STATE OF VERMONT
AGENCY OF TRANSPORTATION

Town Of	GUILFORD	Bridge No.	3N&S
Highway No.	1-91	Log Sta.	
		Surv. Sta.	
1-91 OVER BROAD BROOK & BROAD BROOK ROAD			
ROADWAY PLAN (1 OF 2)			
Designed By	T.C. GAWENUS	Drawn By	R.A. BOTZENHART
Checked By	P.W. SZUSTAK	Bridge Design Supervisor	J.P. HALSTEAD
	Date 01/03	Date	01/03
PROJECT	GUILFORD	PROJECT NO.	IM 091-1(33)
TVGA CAD Drawing No.	PL-1dgn	Date	06/06/08
Bridge Sheet No.		Sheet	6 of 14

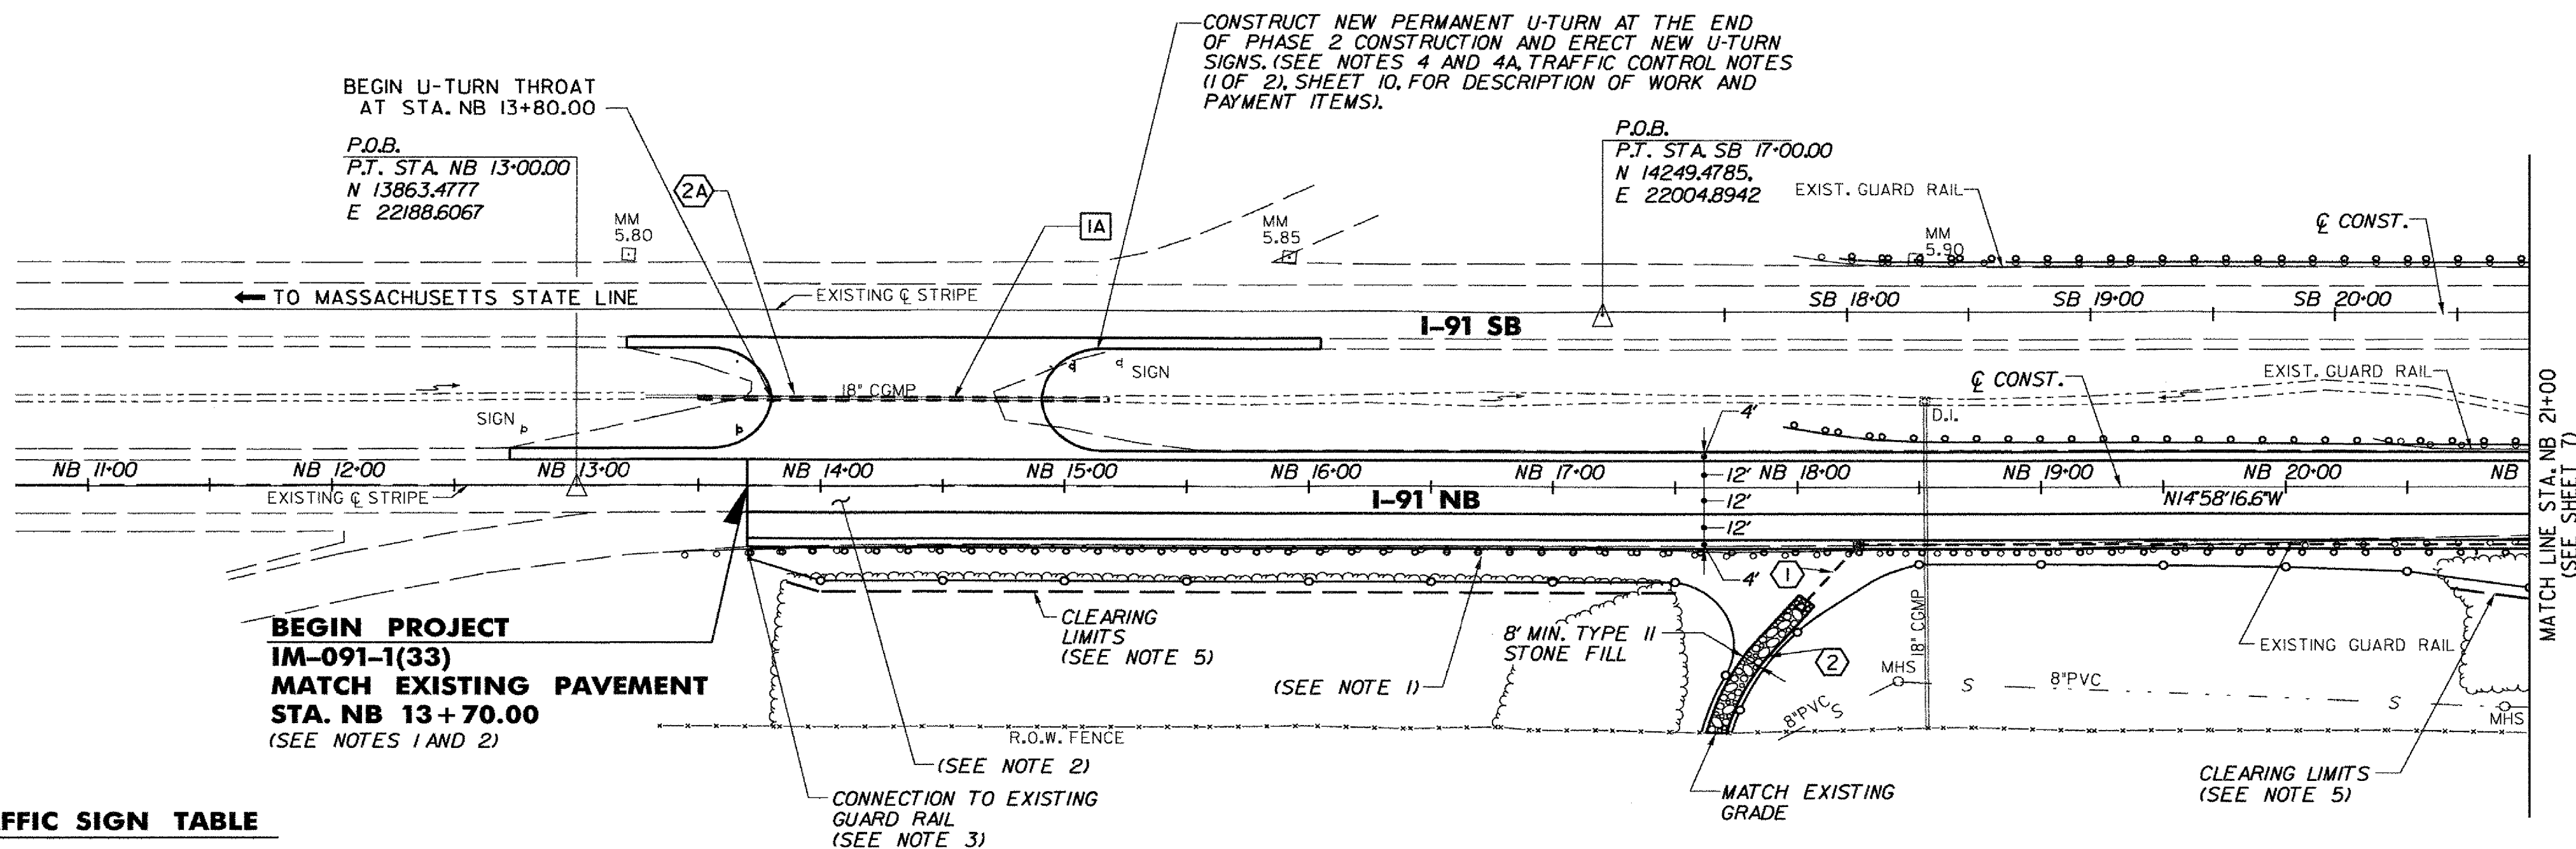
LEFT EXISTING PIPE 1A
ADDED PIPE AND END SECTIONS TO DAYLIGHT AT GRADE (1-8 SLOPES)
